### **REMARKS**

**AMENDMENTS TO THE DRAWINGS**

Fig.16

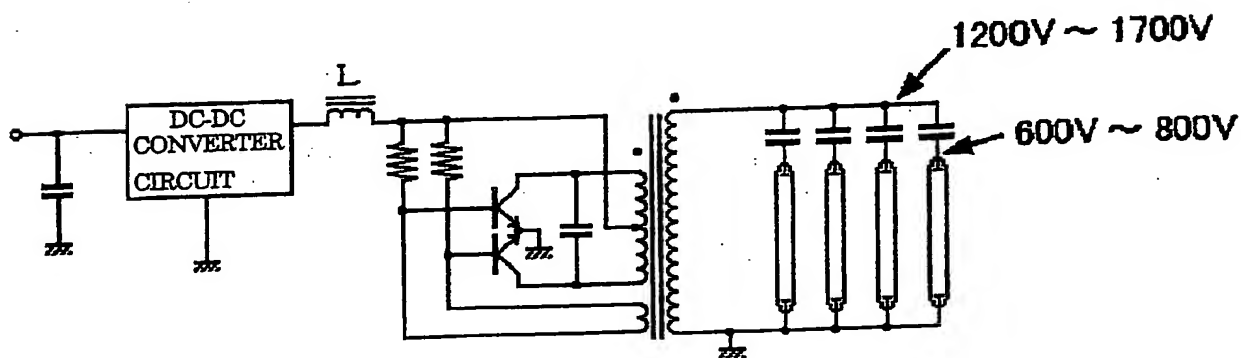
In the Office Action, the Examiner objected to Figs. 16-21 and 24, asserting that these drawings require a legend indicating that only that which is old is illustrated. Attached hereto are drawing corrections to Figs. 16-20 and 24 in which the legend of --BACKGROUND ART-- has been added. However, as to Fig. 21, Applicant respectfully disagree with the Examiner that such a legend is necessary. Specifically, Fig. 21 relates to one embodiment of the present invention in which the illustrated obliquely wound windings are used. See, e.g., claim 13.

The attached sheet(s) of drawings includes changes to Figs. 16-20, 22, and 24. In Figs. 16-20 and 24, the label --BACKGROUND ART-- has been added. Fig. 22 has been separated into Figs. 22a-22d, and certain reference numerals and captions have been deleted. Furthermore, Figs. 22e and 22f have been added.

BACKGROUND ART

~~Fig. 22~~

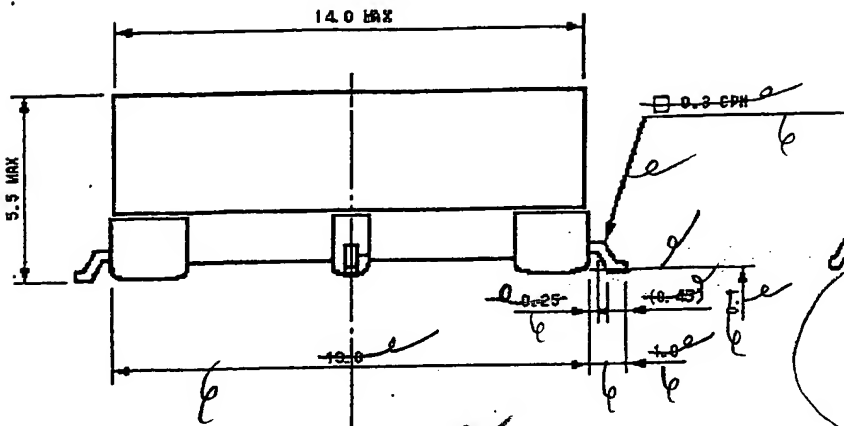
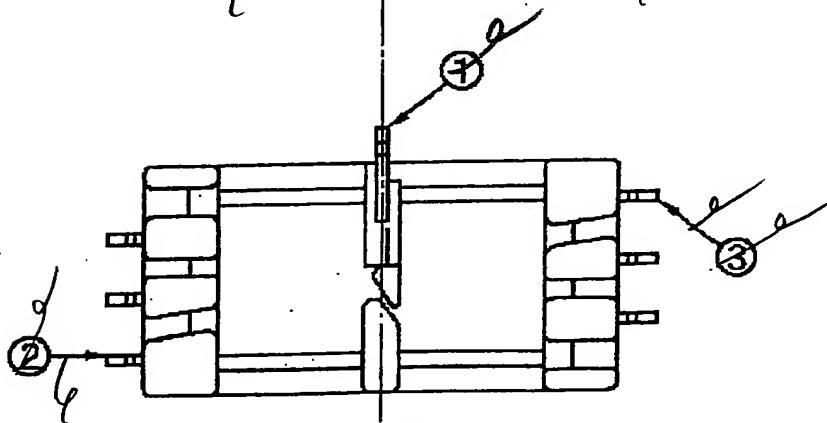
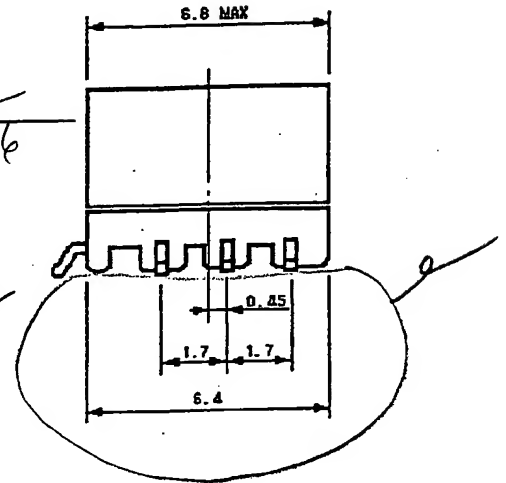
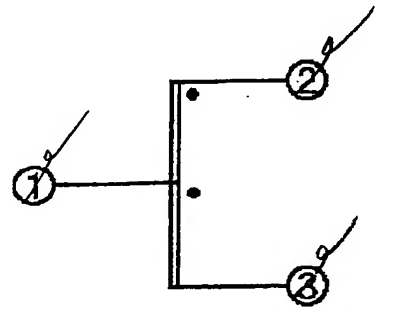
Furthermore, the Examiner objected to reference numerals 1, 2, and 3 in Fig. 22. In the attached drawing corrections, reference numerals 1, 2, and 3 have been removed. Furthermore, Fig. 22 has been separated into Figs. 22a-22d, as suggested by the Examiner.
